SUSITNA HYDROELECTRIC PROJECT  
FERC LICENSE APPLICATION

**BEFORE THE  
FEDERAL ENERGY REGULATORY COMMISSION  
APPLICATION FOR LICENSE FOR MAJOR PROJECT  
SUSITNA HYDROELECTRIC PROJECT  
VOLUME 10B**

CORRESPONDENCE RELATING TO DRAFT LICENSE REVIEW

Comments Received from Agencies Concerning  
the Draft License and the Power Authority's  
Response to These Comments

Figure 2  
POTENTIAL IMPACT LOCATIONS IN THE LOCAL  
IMPACT AREA

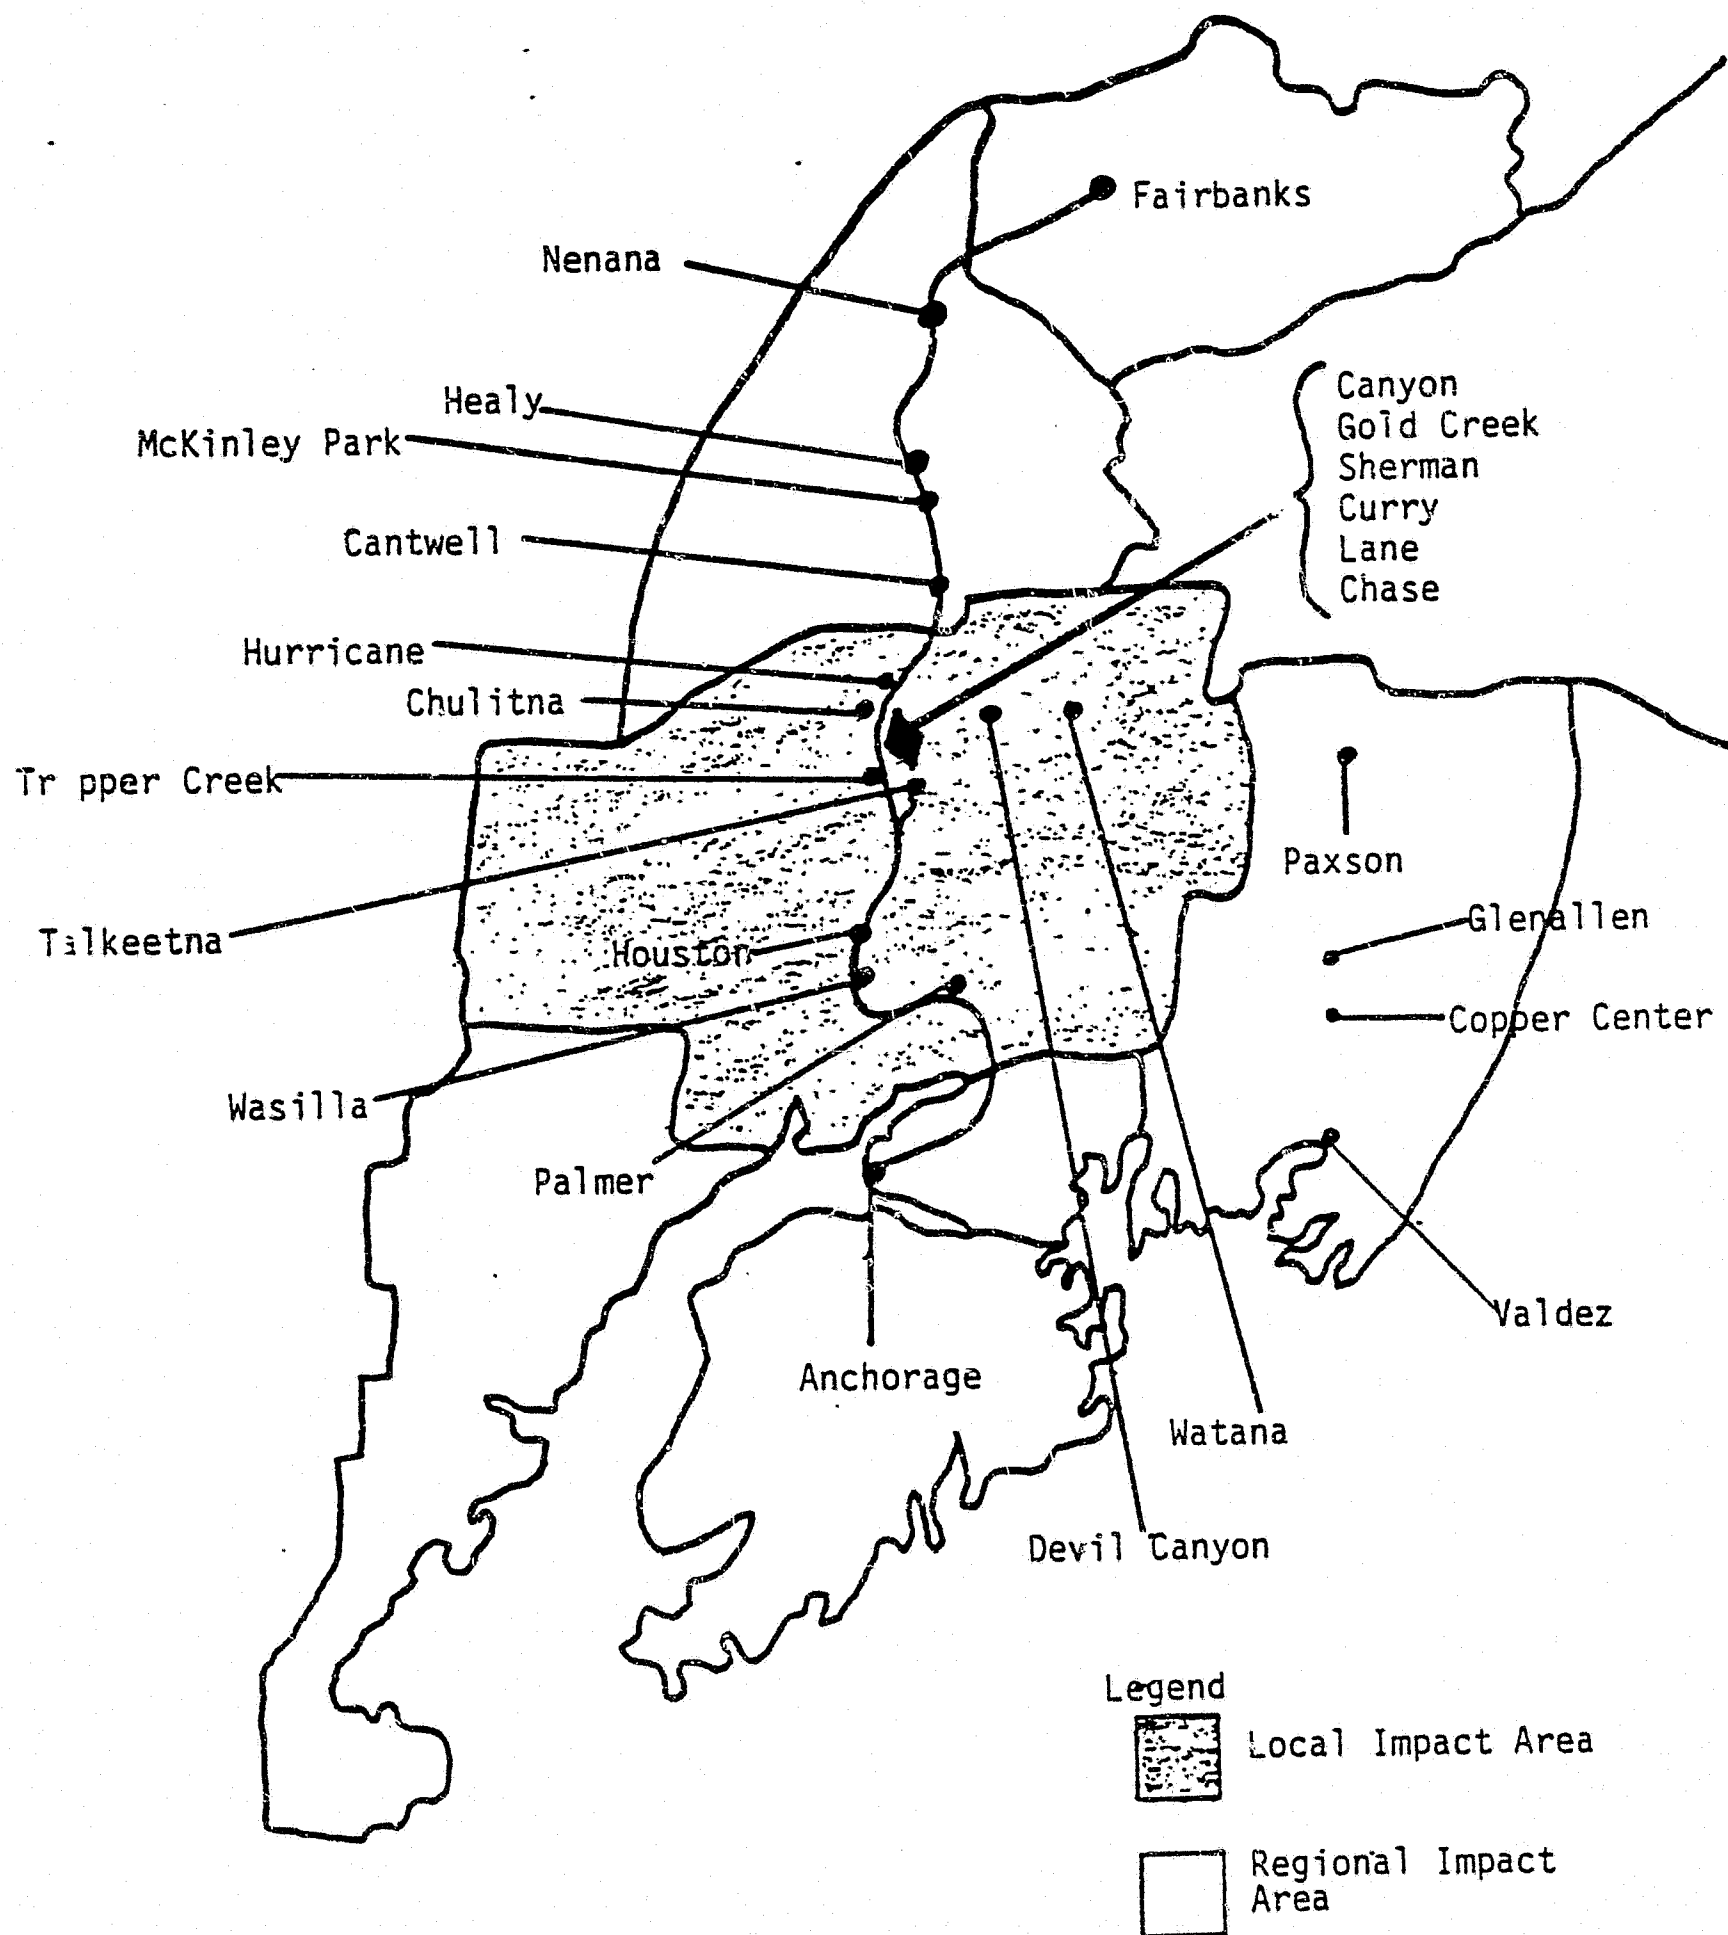
As the nearest communities to the construction sites are quite small, and any settlement by workers would create measurable impacts, it was necessary to consider developing the capability to quantify potential impacts for small geographic areas. Based upon a review of the attributes of these communities, it became apparent that some workers, under certain conditions, would probably be attracted to, and settle in these small communities. As a result, a rather large number of small impact areas were delineated. These are shown in Table 1. A map showing the impact Areas is shown in Figure 2.
